ELECTRONIC APPLICATION OF GREEN	)	
RIVER SOLAR, LLC FOR A CERTIFICATE TO	)	
CONSTRUCT AN APPROXIMATELY 200	)	
MEGAWATT MERCHANT SOLAR ELECTRIC	)	CASE NO. 2020-00387
GENERATING FACILITY IN BRECKINRIDGE	)	
COUNTY AND MEADE COUNTY, KENTUCKY	)	
PURSUANT TO KRS 278.700 AND 807 KAR	)	
5:110	)

## RESPONSES TO SITING BOARD STAFF'S POST-HEARING REQUEST FOR INFORMATION

TO GREEN RIVER SOLAR, LLC
DATED NOVEMBER 3, 2021
GREEN RIVER SOLAR, LLC
PSC CASE NO. 2020-00387

Figure 2. Cross-section of a stylized version of the reverse graded filter. (Courtesy of the Missouri Geological Survey)

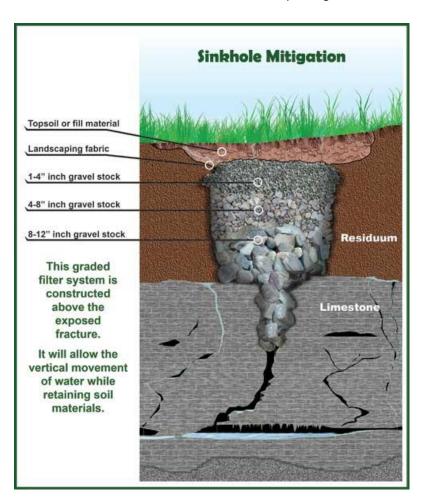
Provide any reports or documentation that explains the proposed reverse Request 3.

grade filter method for remediation over low-risk sinkholes.

Thus, the reverse graded filter (Figure 2) consists of placing boulders or slabs of rock wider than half the throat diameter to form an arch across the bottom opening.

Successive layers of rock are then placed which are sized finer than the underlying layer, but large enough not to fill the interstices between the rocks in the underlying layer. The uppermost layer is then capped with geotextile fabric, usually a micro-perforated non-woven material. Uncompacted soil lifts are then placed above the fabric. It is often recommended to fill the soil slightly higher than the grade surrounding the excavation, to allow for settling as the soil compacts. The soil should be planted with the same turf used for the solar field.

The goal of the reverse graded filter is to allow surface soils to be retained and prevented from raveling into the subsurface. This will allow the water to flow through the epikarst, into the gravel filter, and downward into the underlying vadose and phreatic zones. Thus, contaminants are effectively mitigated by the action of soil organisms, and not carried down into the underlying aquifer.

## **CONCEPTUAL SITE PLAN**

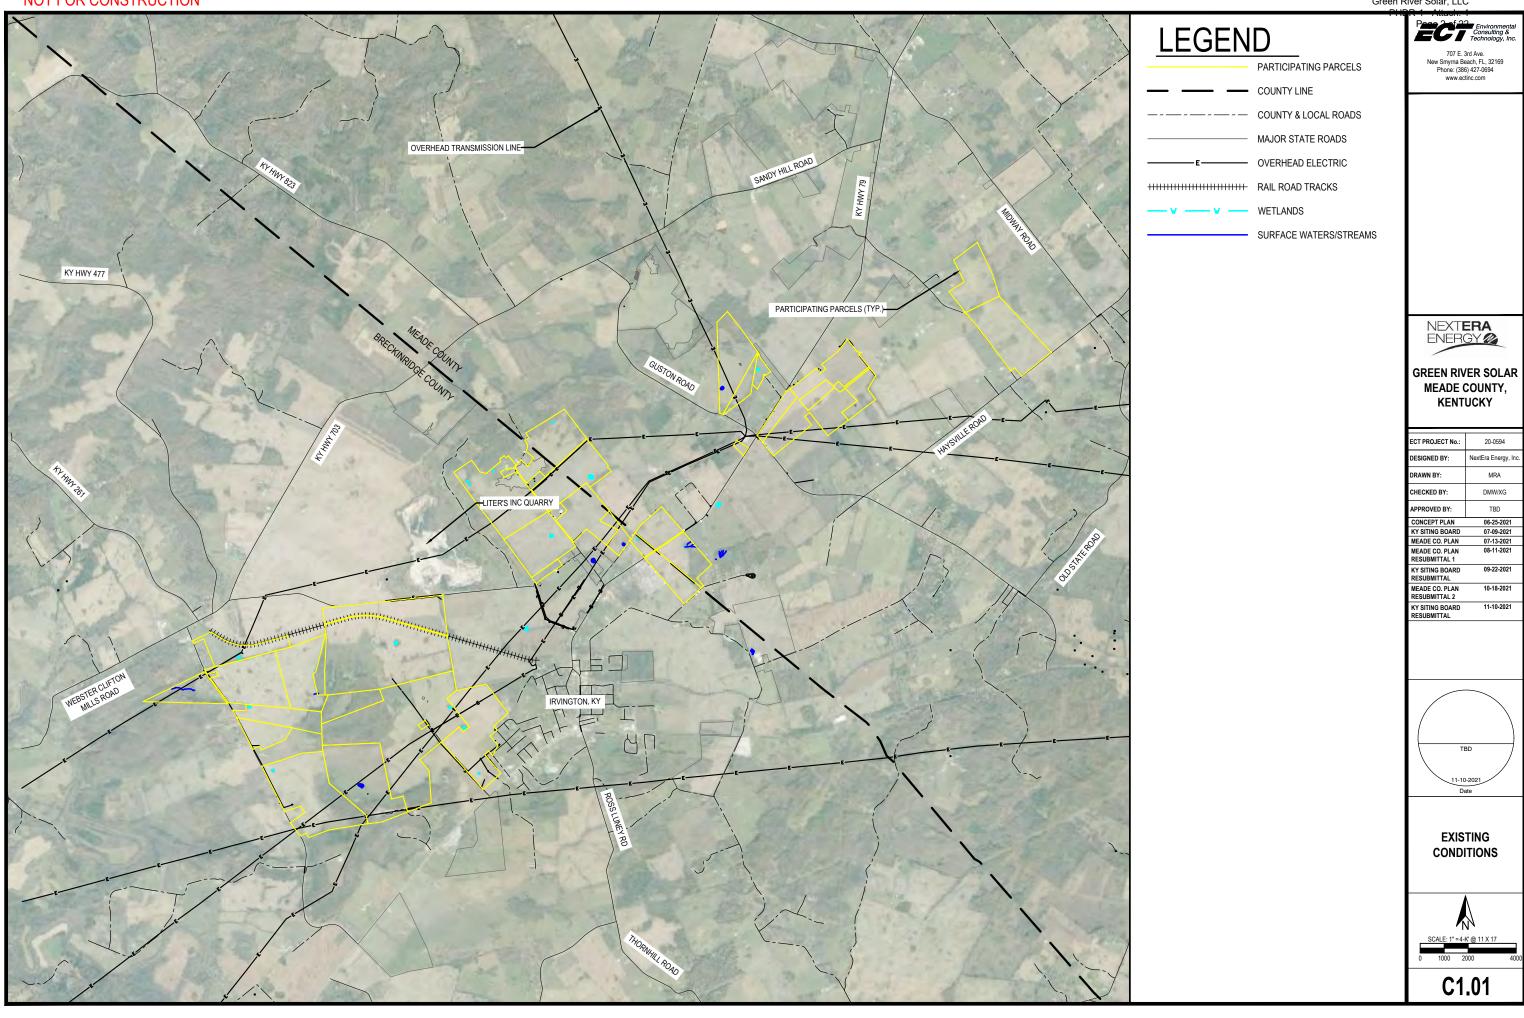
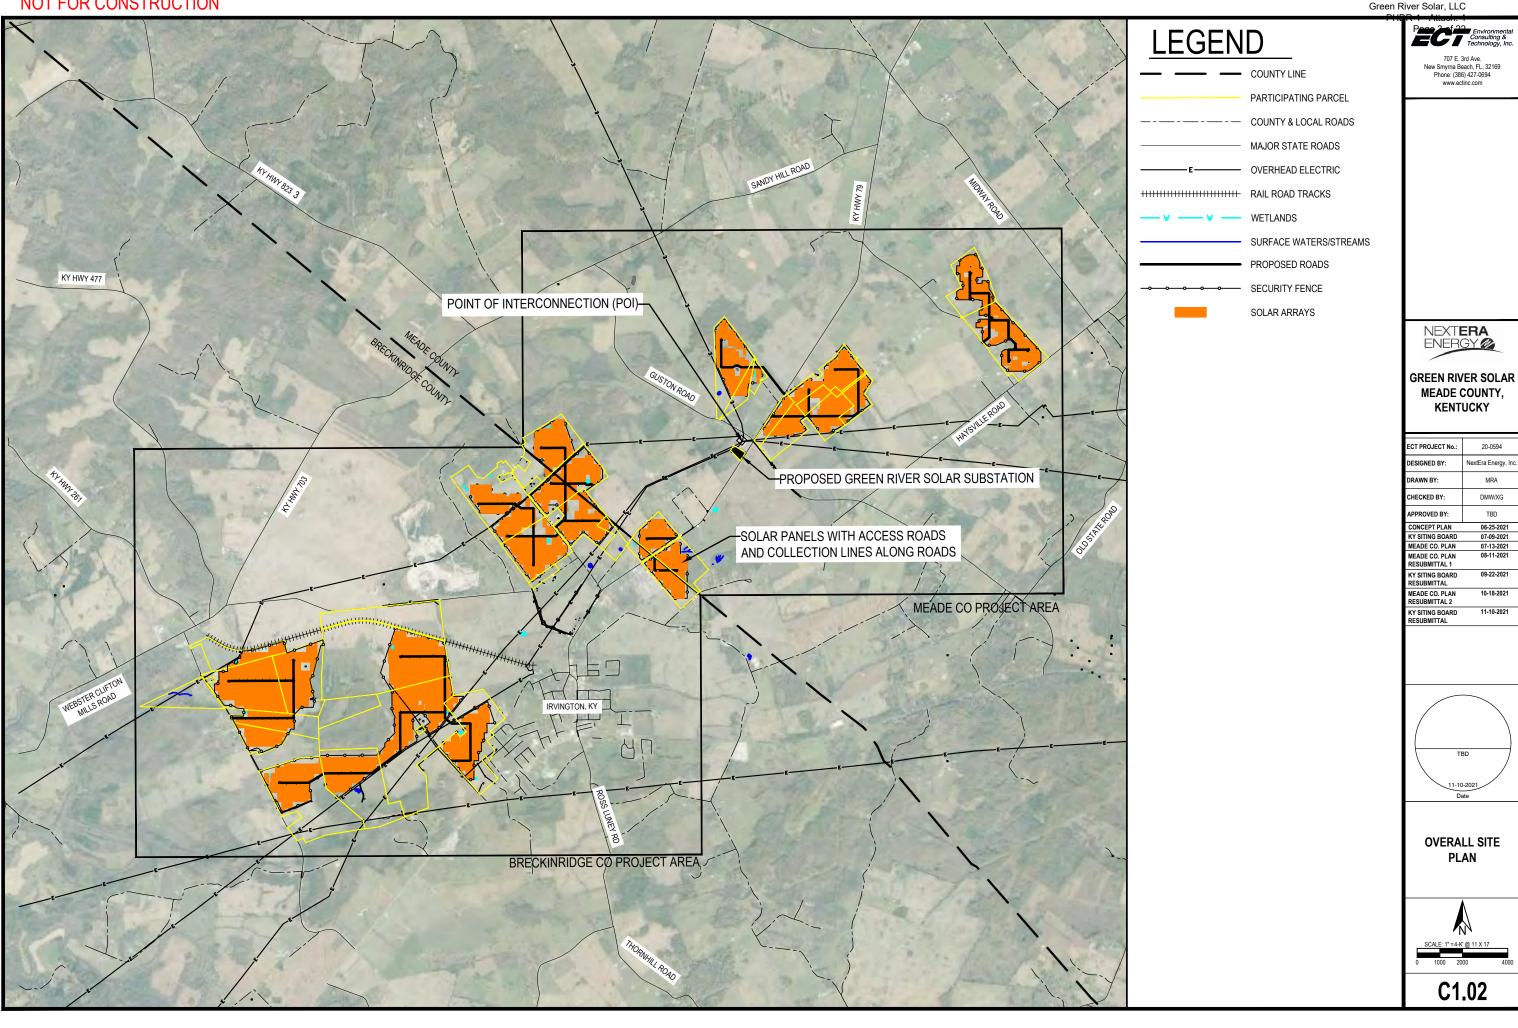
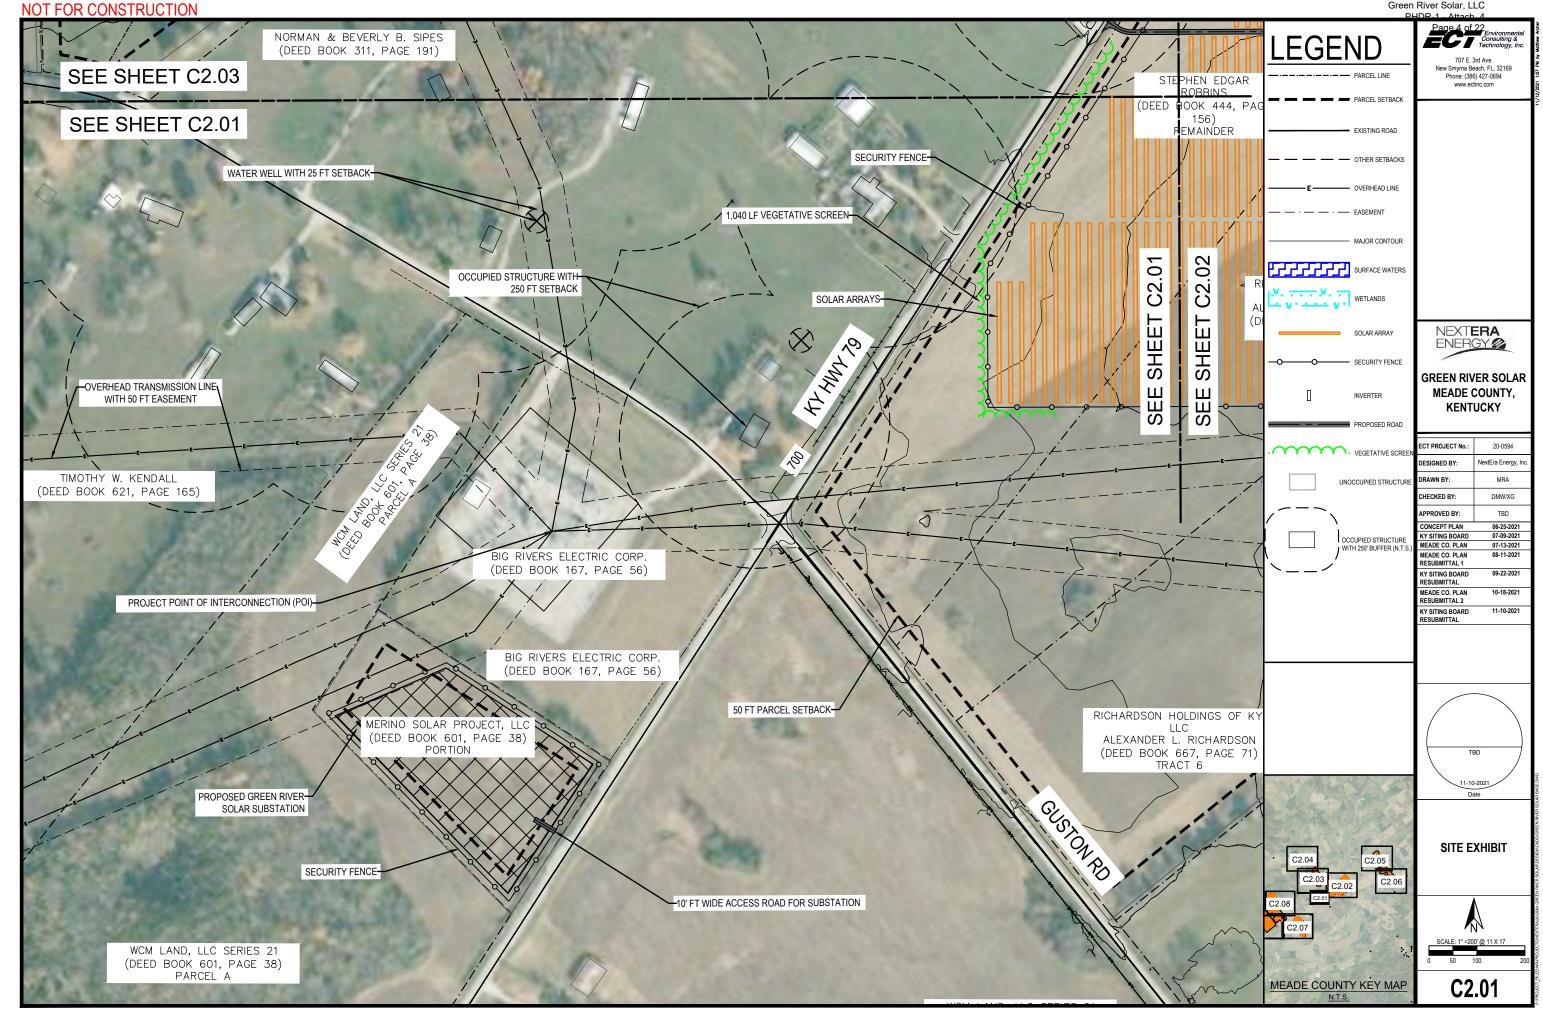
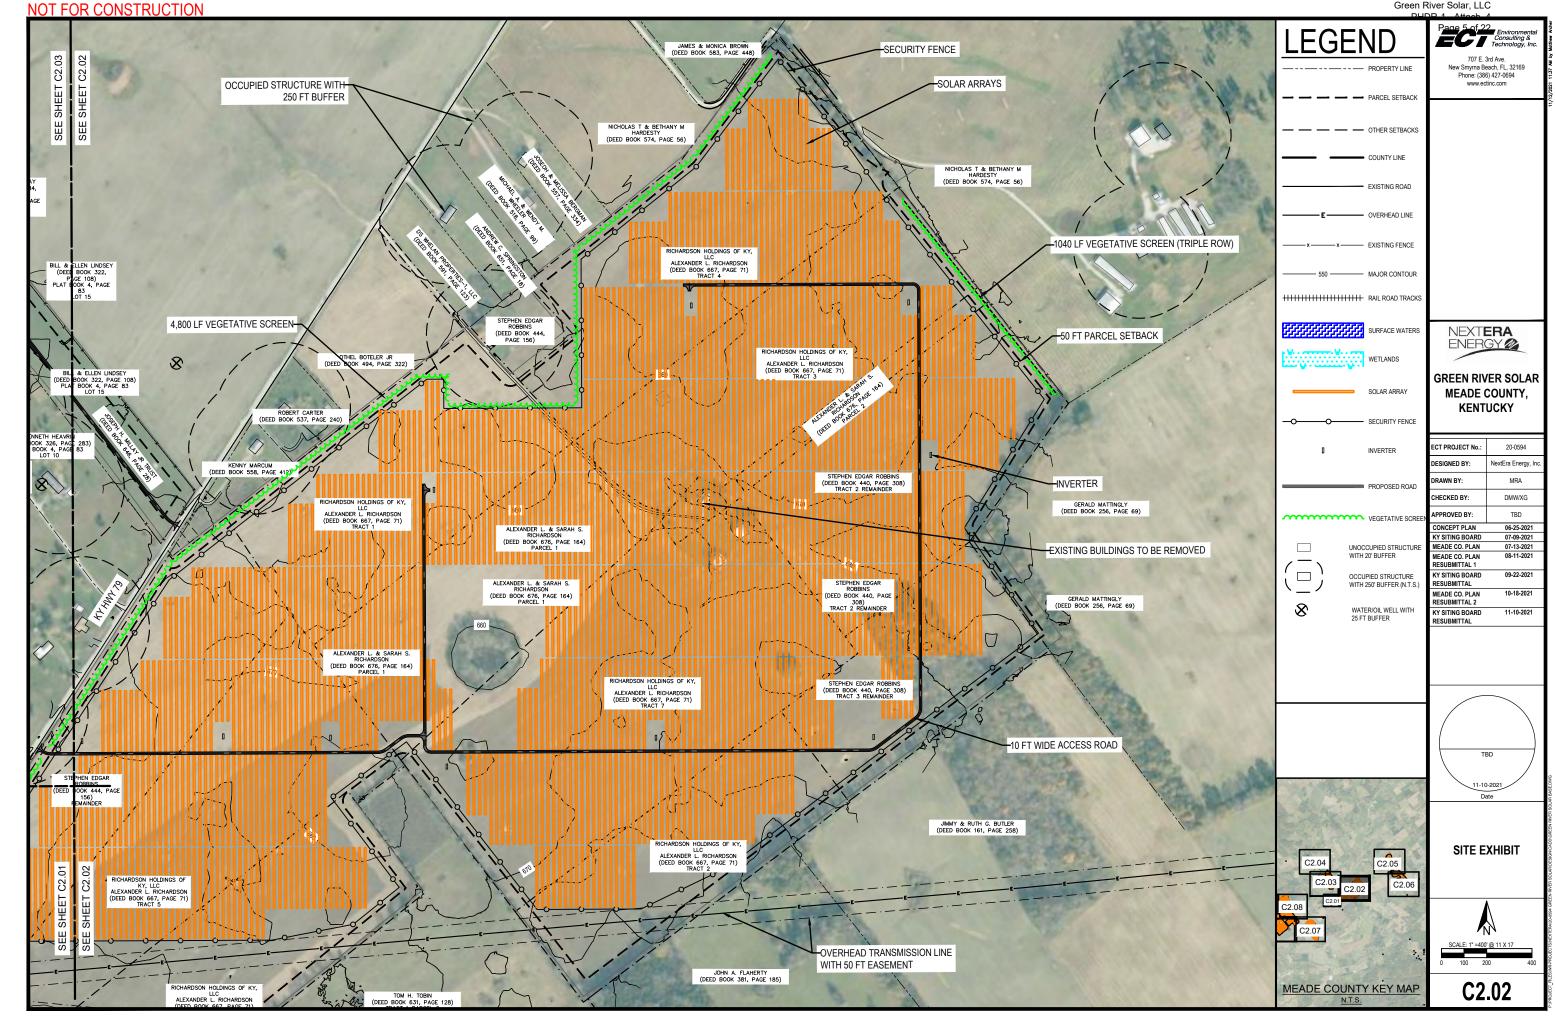
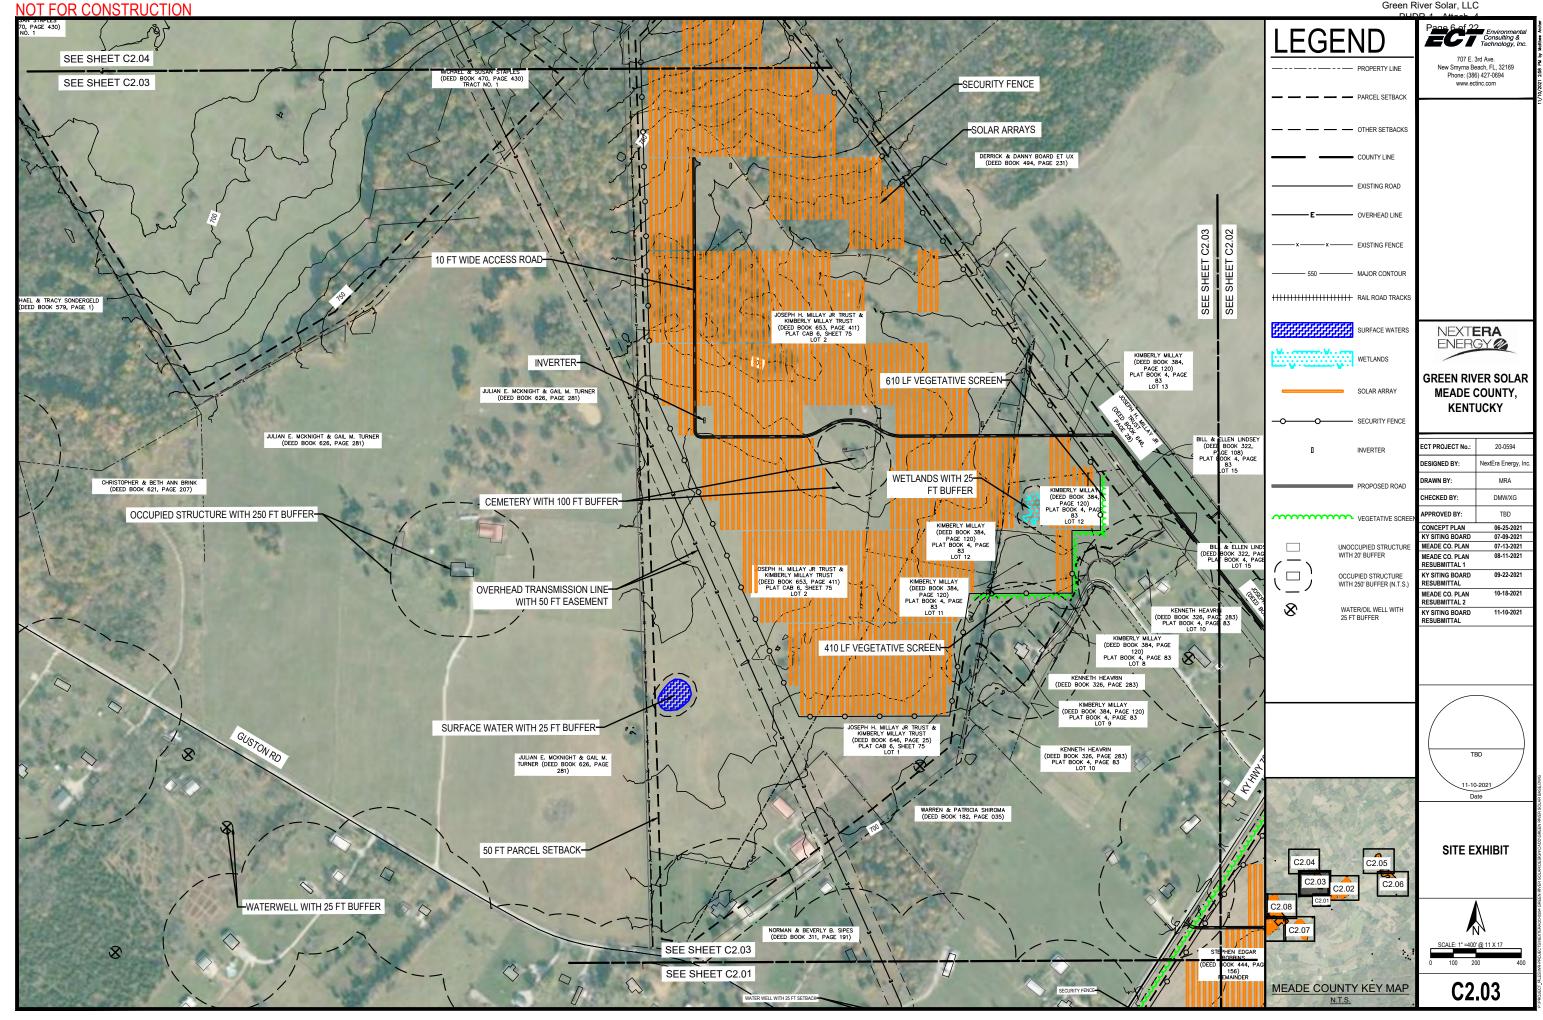
Request 4. Provide a copy of the Site Plan with updated and detailed proposed vegetative buffers. If any residences with direct view of solar facilities or equipment will have no vegetative buffering, explain why.

Please see Attachment 4 for updated Conceptual Site Plan, including updates to proposed vegetative buffers. Vegetative buffers are planned for all residences with direct view of the solar facilities or equipment.
